DEFENSE NUCLEAR FACILITIES SAFETY BOARD

September 23, 2002

Staff Issue Report

SUBJECT: Safe Storage of Sodium Fluoride Traps, Oak Ridge National Laboratory

Figure 1: Pressure in the two monitored NaF/UF₆ traps, and temperature in Bldg 3019.

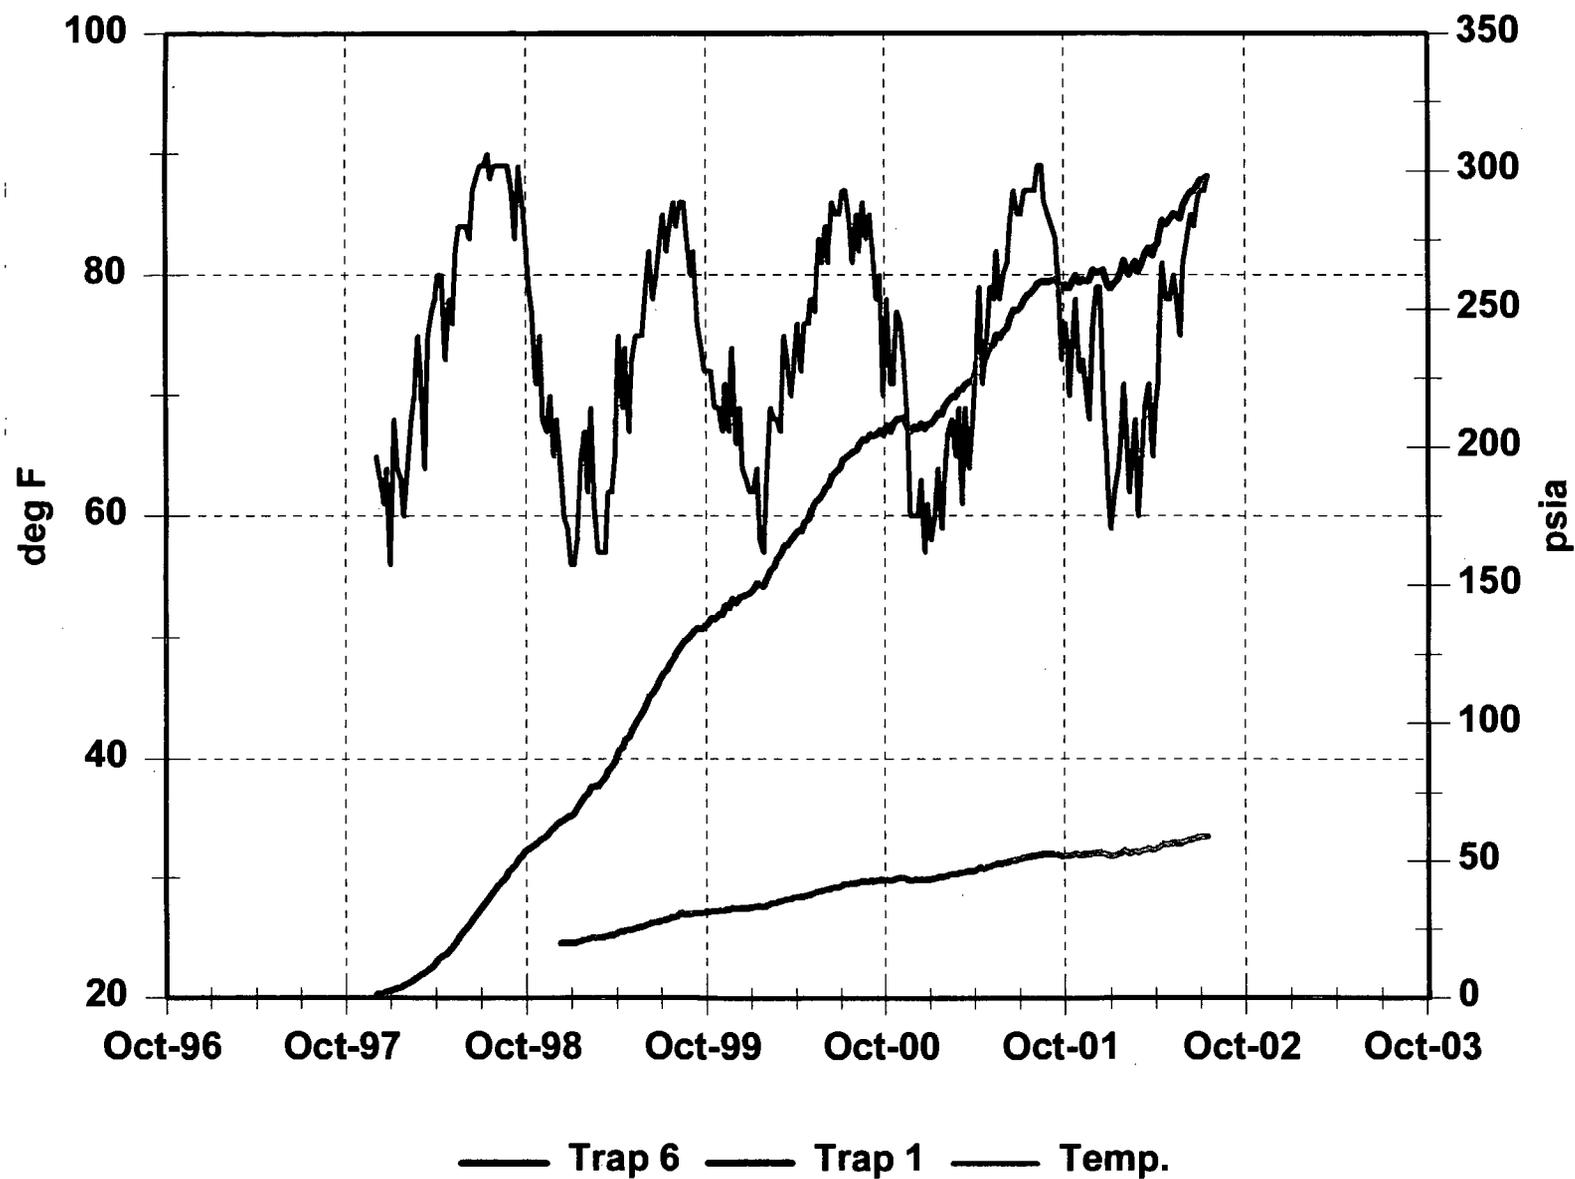
Radiolysis in NaF Traps and Pressure Monitoring. The internal pressure of the traps is increasing because of radiolysis of the NaF-UF₆ compound, which evolves fluorine gas. ORNL monitors the pressure in two traps (traps #1 and #6) stored in Cell 1 of Building 3019A. Figure 1 (attached) presents pressure data provided to the Board's staff by ORNL. The figure shows that the pressure in trap #6 is approaching 300 psig and is continuing to increase. Trap #1 contains considerably less material and has generated less pressure.

The pressure instrument is calibrated for pressures up to 250 psig. Therefore, ORNL is now estimating the pressure for trap #6 based on extrapolation of the calibration data, contrary to industry standards for calibration. Hence, uncertainty exists in the pressure measurements, and this uncertainty will increase as the pressure continues to rise above the calibrated range of the instrument. Furthermore, trap #6 is not believed to be the worst-case trap; thus higher pressures are expected to exist eventually in nine traps stored in the Building 3019A tube vaults. At this time, only one other trap is calculated to have a higher pressure than trap #6.
